Invitation for Bid No. 2021-090

Union County Structured Cabling & Audio Visual

ADDENDUM No. 1

ISSUE DATE: July 23, 2021

||TE202

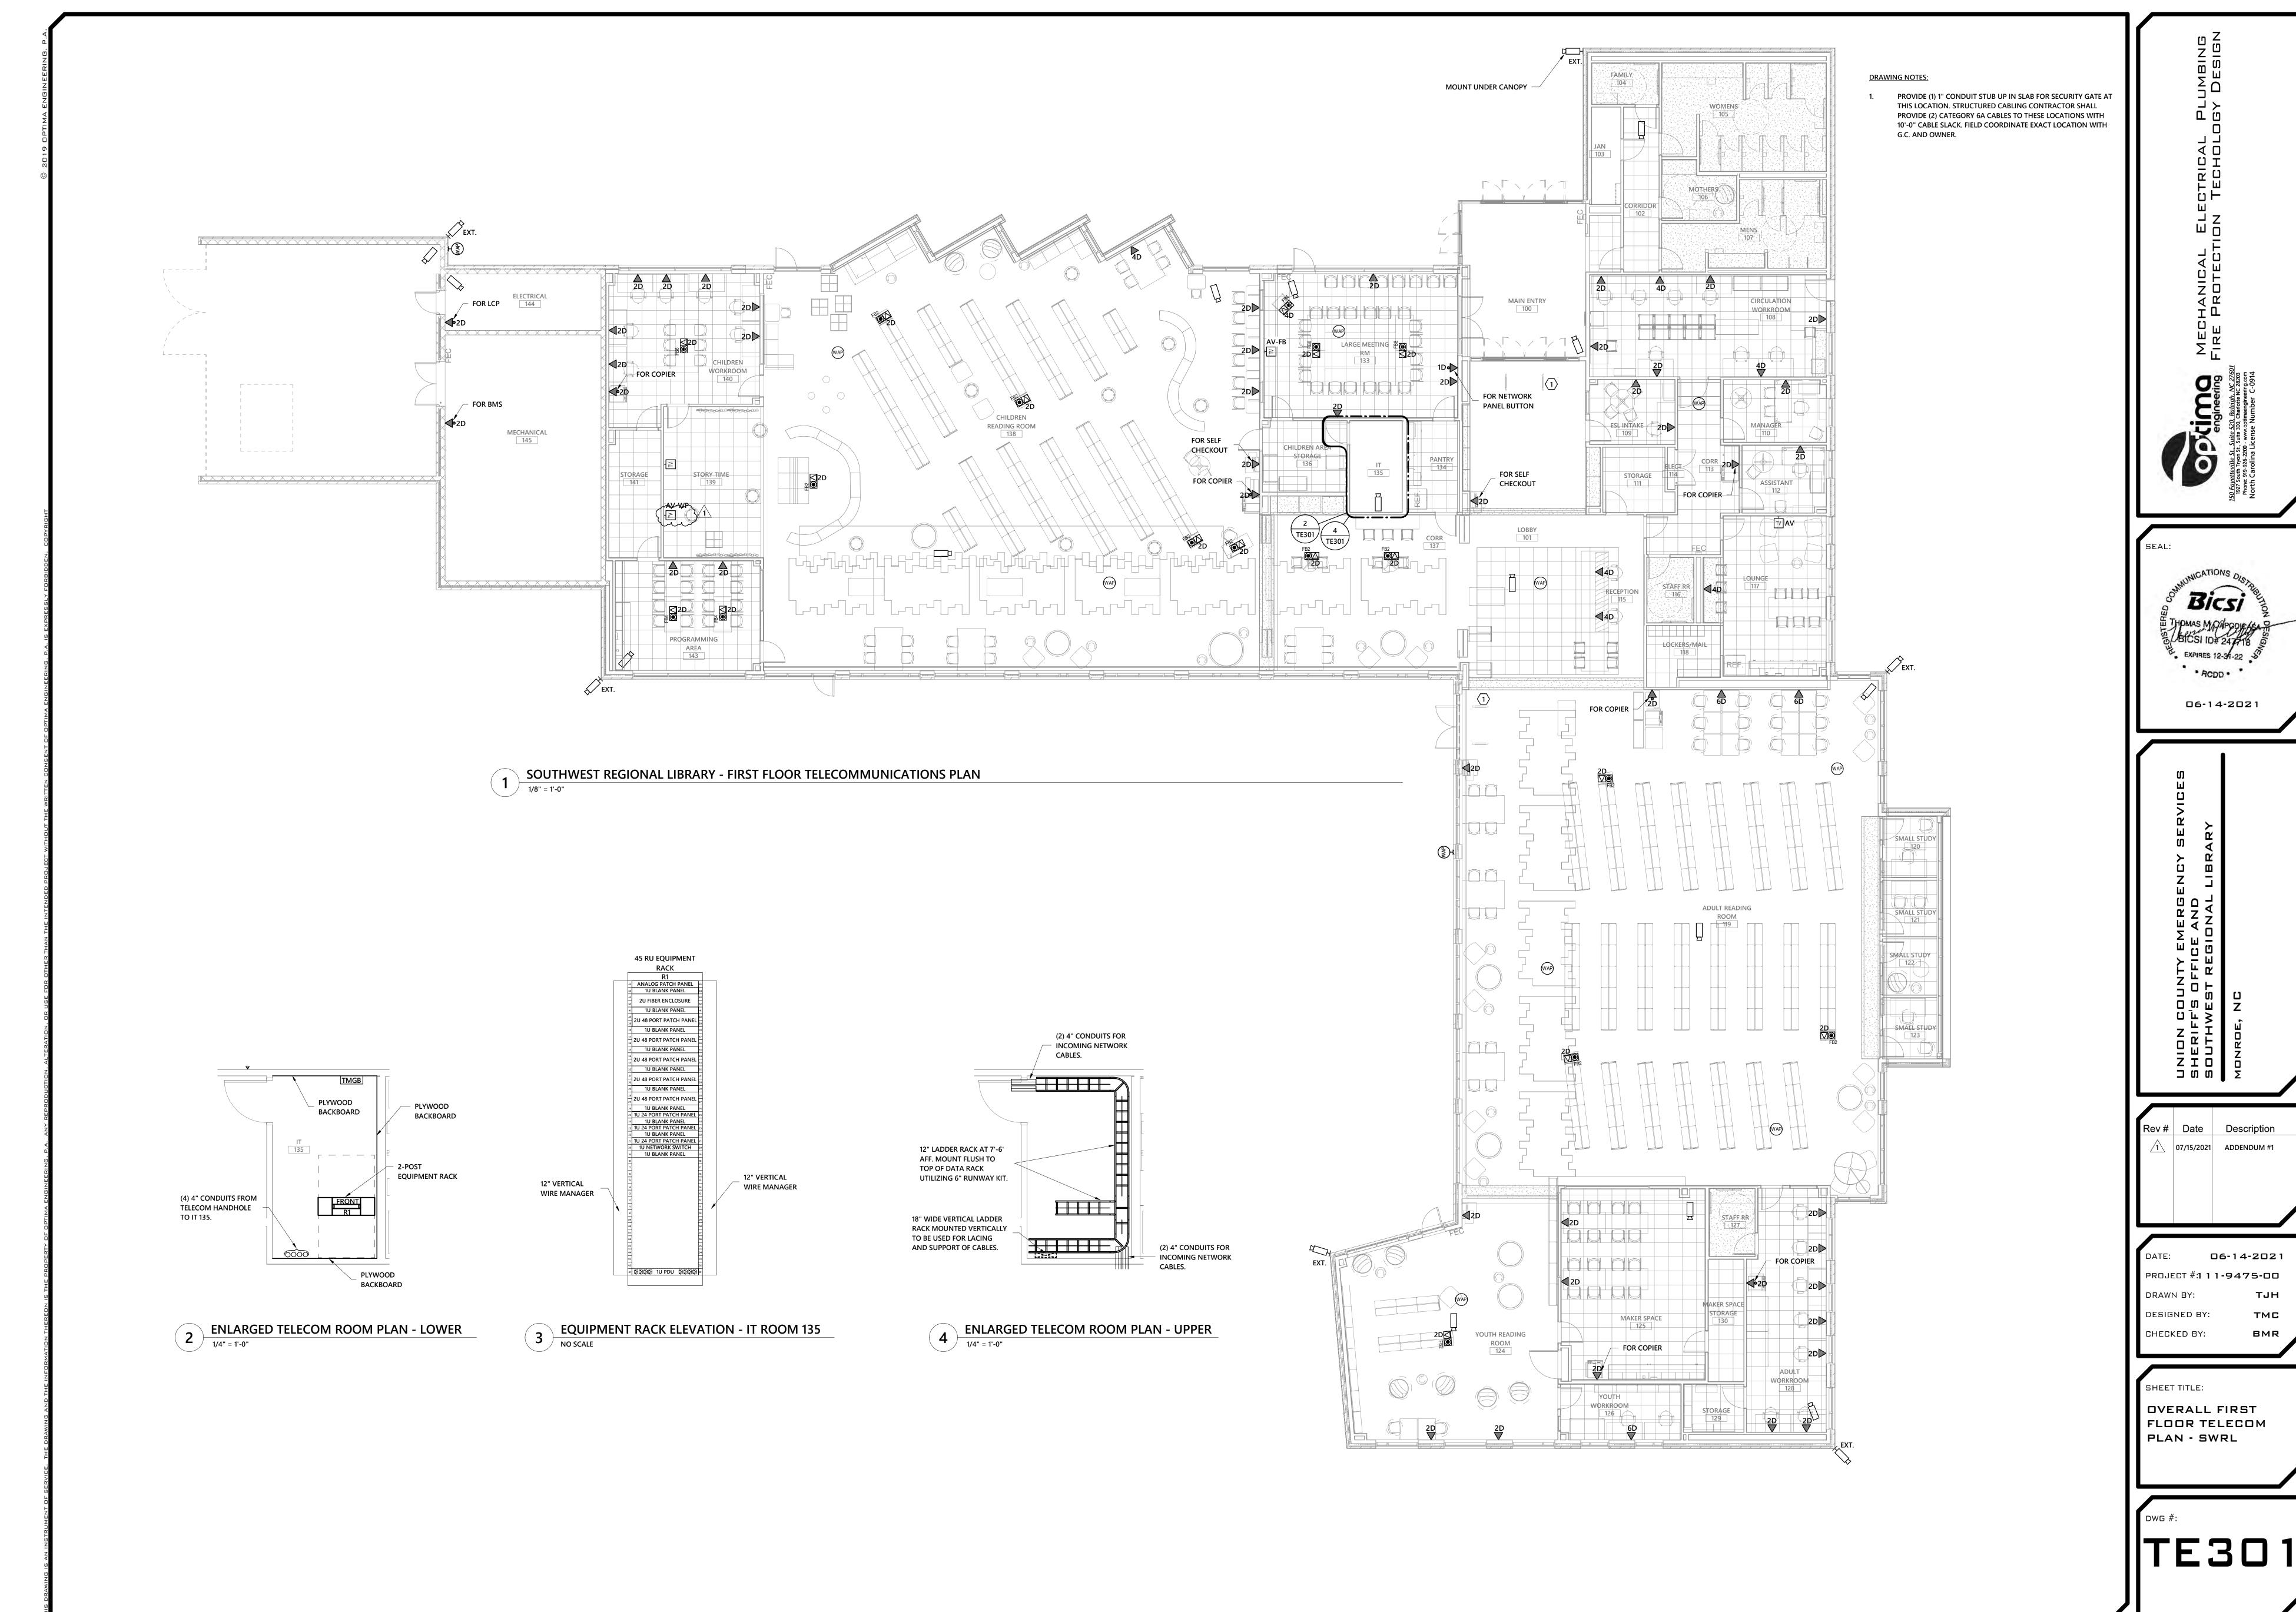
- 3) Removed Keyed Note #3.
 - 4) Added video wall text to Training Room 1400.
- d) Telecommunications Sheet TE202 (SO), (Revision 1)).
 - Removed all Wall Plated (WP) symbols from Telecom Plans.
